MINOR VARIANCE REPORT

APPLICATION: CAV A/188/2022

Owner/Applicant	Agent	Location of Land
	Cedar Springs Landscape Group c/o Justin Tenhage 3242 South Service Road South Oakville ON L6L 6T1	PLAN 581 LOT 39 2069 Glenforest Crescent Town of Oakville

Excerpt of the Site plan by the applicant:

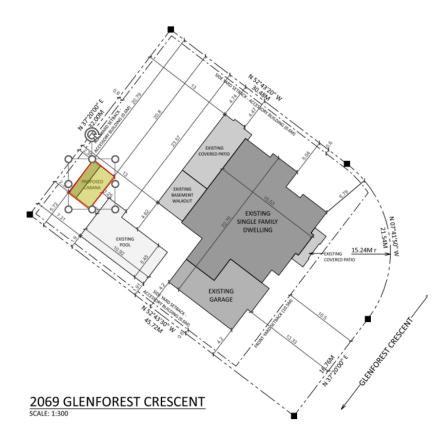
Variance #1 – Lot Coverage (Supported)

The applicant is seeking relief from Zoning By-law 2014-014, as amended, to permit an increase in maximum lot coverage (for all buildings on the lot) from 25% (353.00 square metres) to 37.00% (521.40 square metres). Upon additional review it appears that the applicant may have taken the existing Residential Floor Area Ratio of 35.5% and applied it as lot coverage and has added the increase of the cabana to arrive at a calculation of 37%. Based on the previous February 9, 2016 Committee of Adjustment application (CAV A/032/2016), it appears that the existing lot coverage and previously proposed cabana had a lot coverage of 24.99% which complied with the Zoning By-law. The applicant should clarify the magnitude of the requested variance as a result of the addition of a cabana with a proposed area of 20.07 square metres. It is suspected that the required lot coverage will be much lower than requested. The intent of regulating lot coverage is to prevent the construction of a dwelling with a mass and scale that appears larger than the dwellings in the surrounding neighbourhood and to ensure that adequate open space is available on a lot for outdoor amenity areas and stormwater infiltration. The proposed changes are not related to the existing dwelling and the increase is only related to the proposed Cabana which is located at the rear of the existing dwelling. The proposed cabana is not visible to the public realm and would not trigger privacy issues or shadow impacts on neighbouring properties. It is Staff's opinion that the revised proposed increase in lot coverage to accommodate the proposed cabana is minor in nature, will not have adverse impacts on the surrounding properties and is desirable for the development of the subject property.

In summary, based on the application as submitted, Staff are of the opinion that the application satisfies the applicable tests under the Planning Act. Should the Committee concur with staff's opinion, the following conditions are requested:

- 1. That the accessory building (Cabana) be built in general accordance with the submitted site plan and elevation drawings dated October 12, 2022; and
- 2. That the approval expires two (2) years from the date of the decision if a building permit has not been issued for the proposed construction.
